SUNNINGDALE PARISH COUNCIL

21/00334/TPO: Copper Beeches 12 Chanctonbury Drive Ascot SL5 9PT

T1 - Conifer - fell, T2 - x2 Cherry - Crown reduction by 1.5m to leave a height of 4.5m and spread of 3.5m, T3 - Birch - fell, T4 - Prunus Pissardii - Crown reduction by half, to leave a height of 3m and spread of 2.5m, T5 - Conifers - trim back to attain 1 metre clearance from the roof of the shed, T6 - Portuguese Laurel, cut back the width by 2 metres to reduce overhang, T7 - x 2 Sycamore - cut back 3 lower limbs on each tree by 1.5 metres to reduce the overhang on the rear lawn. (TPO 1 of 1978).

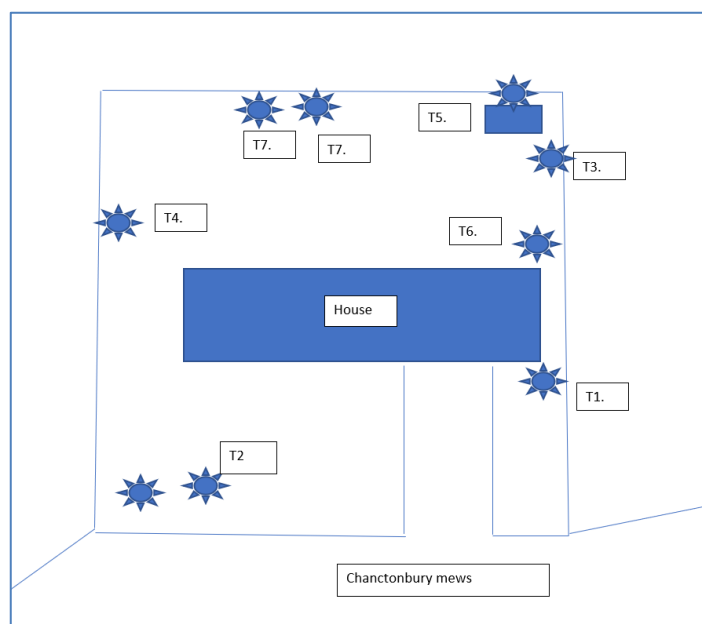
The application requests a substantial amount of tree works, which are not supported by any Arboricultural justification other than a few photographs. The site plan is shown below.

In the absence of this arboricultural information it is unclear how these trees relate to the trees referenced in an earlier application 17/03394.

Under this previous application, the site plan for the trees in question (2 x sycamores) was as follows:-

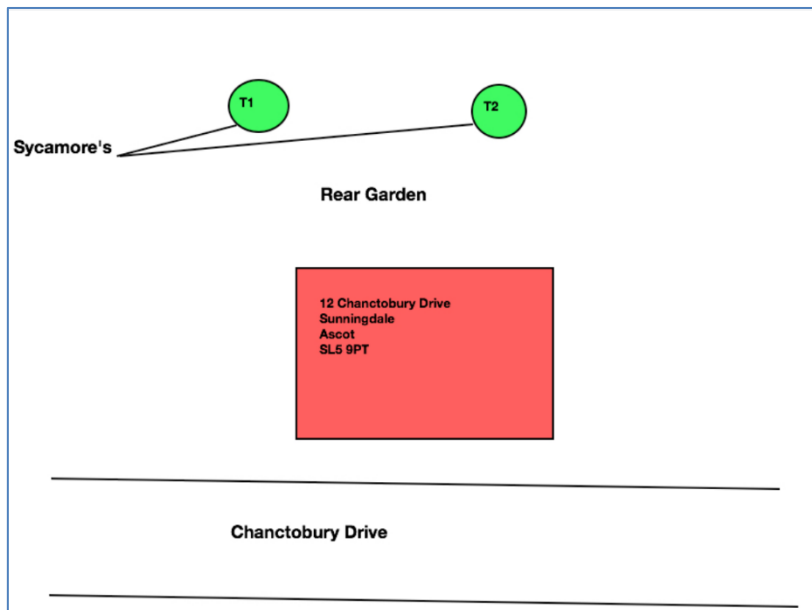
This application was Refused permission “to reduce the height of T1 by up to 6m and lateral spread by up to 4m and reduce the height of T2 by up to 7m and lateral spread by 4m. These are very prominent trees which are clearly visible above the roof line from Chanctonbury Drive making a significant contribution to the street scene and appearance of the local area. The Council considers that the proposed crown reduction works are excessive given the information submitted with the application”.

It is unclear how these two sycamores (T1 and T2 in 17/03394) correspond to the trees in application 21/00334. Are they T7?

Given the disparity between these two applications and the prominence of these trees we would urge the Tree Team to conduct a Site Visit to establish what exactly is being requested and to which tree.
